PG&E Letter DCL-04-141

Docket No. 50-275, OL-DPR-80  
Docket No. 50-323, OL-DPR-82  
Diablo Canyon Units 1 and 2  
Response to September 8, 2004, Request for Additional Information Regarding  
License Amendment Request 03-18, "Revision to Technical Specifications 5.5.9,  
'Steam Generator (SG) Tube Surveillance Program,' and 5.6.10, 'Steam Generator  
(SG) Tube Inspection Report,' for 4-volt Alternate Repair Criteria for Steam  
Generator Tube Repair"

**PG&E Response to the September 8, 2004, NRC Request for Additional Information Regarding License Amendment Request 03-18, "Revision to Technical Specifications 5.5.9, 'Steam Generator (SG) Tube Surveillance Program,' and 5.6.10, 'Steam Generator (SG) Tube Inspection Report,' for 4-volt Alternate Repair Criteria for Steam Generator Tube Repair"**

Figure 1-A  
Leak-Before-Break Analysis Leak Rates for Diablo Canyon Unit 1

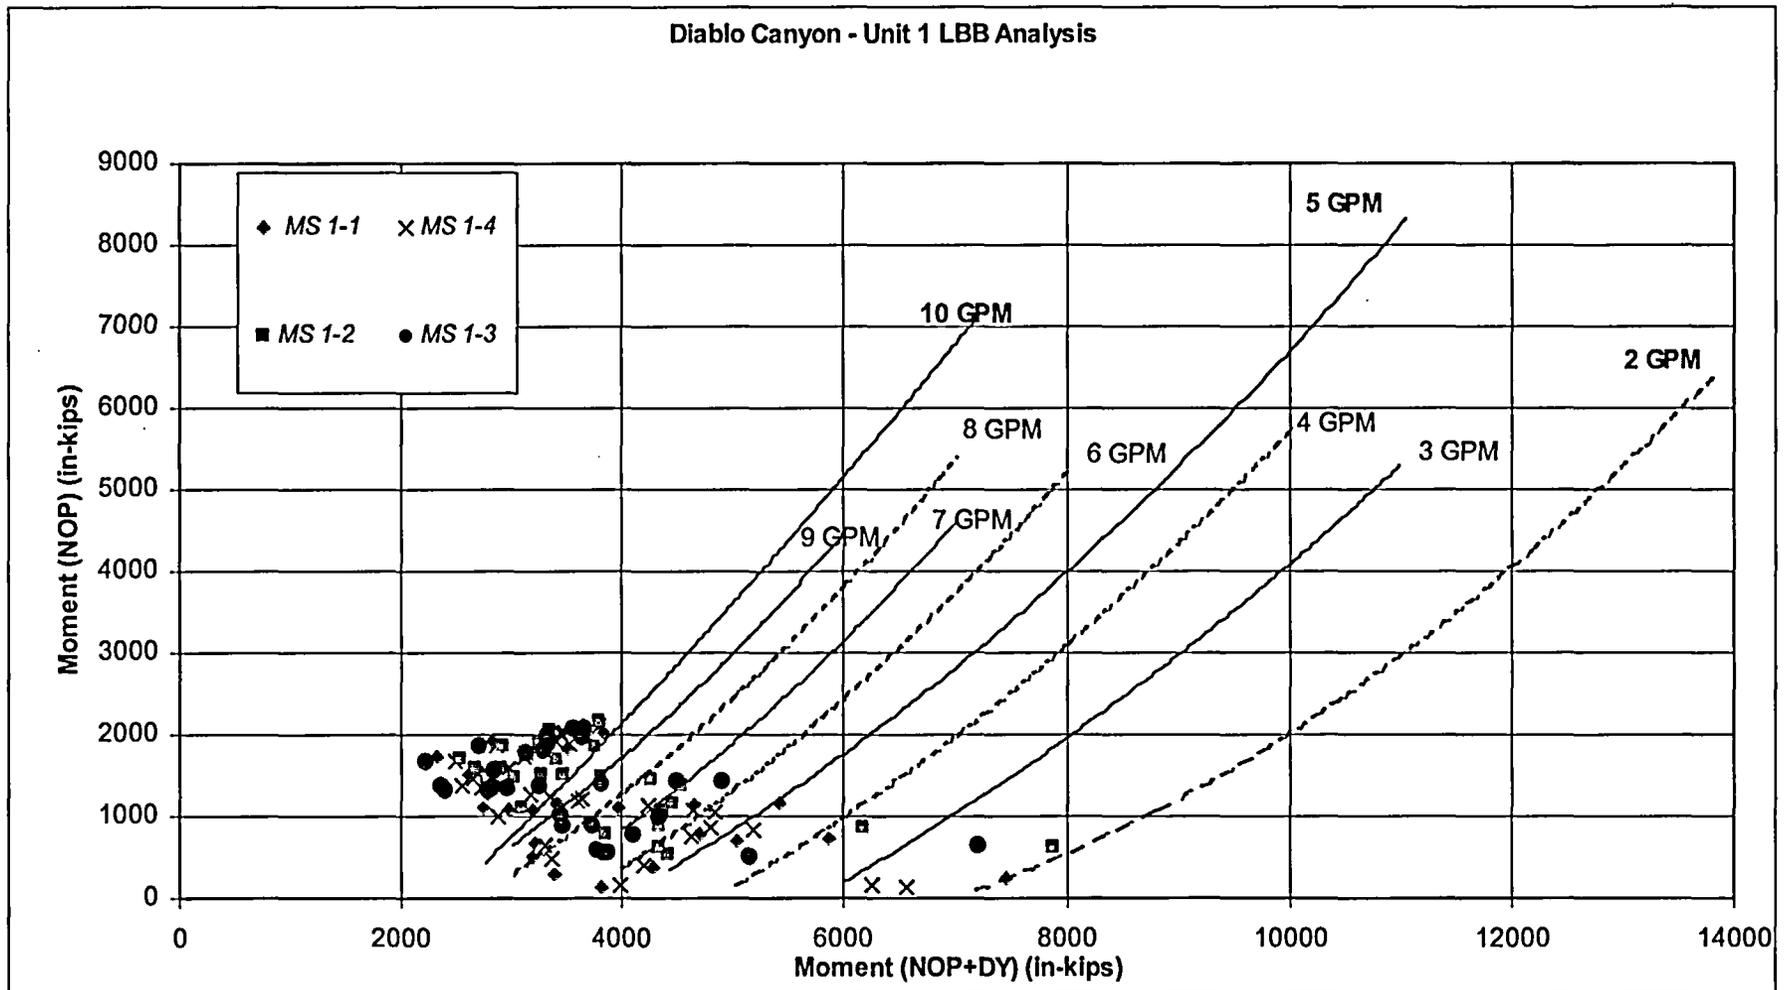
Figures 1-A and 1-B illustrate the LBB analysis leak rates graphically for Unit 1 and Unit 2, respectively. The figures have also been updated to show additional leakage rate curves from those originally provided on pages 5-21 and 5-22 of the LBB analysis report SIR-03-146, Revision 1.
